# Intel® 80219 General Purpose PCI Processor

## Specification Update

*July 2004*

Document Number: **274020-002**

**Figure 2. Intel® 80219 General Purpose PCI Processor P\_BMI Signal Implementation for Intel® 80219 General Purpose PCI Processor B-0/B-1 Stepping**

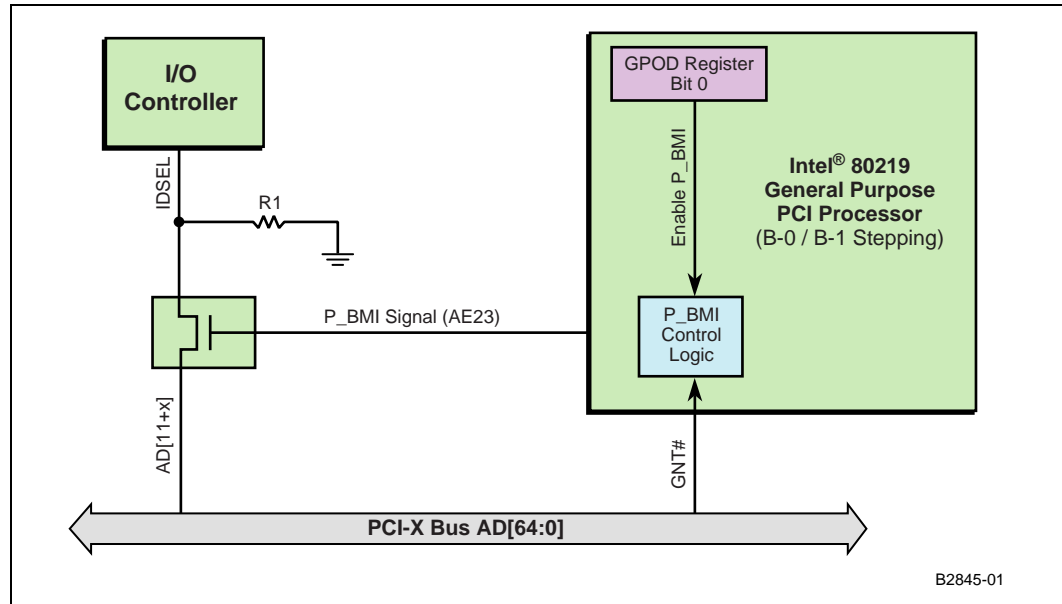
## 1. Signal NC2 was renamed to P\_BMI (AE23). New function added to signal P\_BMI.

The P\_BMI (AE23) signal has been added to the Intel® 80219 general purpose PCI processor. This signal replaces, using an external GPIO pin for Initialization Device Select (IDSEL) control of an I/O device during host configuration cycles.

The 80219 has eight integrated General Purpose Input Output (GPIO) pins, referred to as GPIO[7:0]. These pins, along with the new PCI-X Bus Master Indicator (P\_BMI) signal, can be used to control the IDSEL to the I/O device. External circuitry is no longer required other than a simple switch. The output function of the P\_BMI signal is controlled by the GPIO Output Data Register (GPOD), Bit 0 as shown in Table 1. The P\_BMI signal is always driven and defaults to driving low at power up.

The IDSEL signal is used as a chip select during configuration cycles initiated by the BIOS, operating system or 80219. The GPOD[0] can be driven low in firmware, thereby disabling the P\_BMI signal and hiding the host I/O device from the system, by turning off its IDSEL. When the 80219 intends to perform configuration cycles in the PCI bus segment of the I/O device, the P\_BMI signal should be asserted high by driving the GPOD[0] high. The affect of these two operations is, that the I/O device is initialized and controlled by the 80219. More care must be taken with the gate chosen to control IDSEL, since most host bridge controllers do not use PCI address stepping. With IDSEL being a synchronous signal, with respect to CLK, the switch used must be a sub nanosecond propagation delay device (e.g., Pericom PI5C3303). In Figure 2, the P\_BMI signal is used to control a MUX/DeMUX switch that is used to enable/disable IDSEL to the I/O device.

**Note:** The host BIOS does not require any modifications to accommodate this implementation. All the responsibility for I/O device configuration and resource falls to the 80219 firmware.
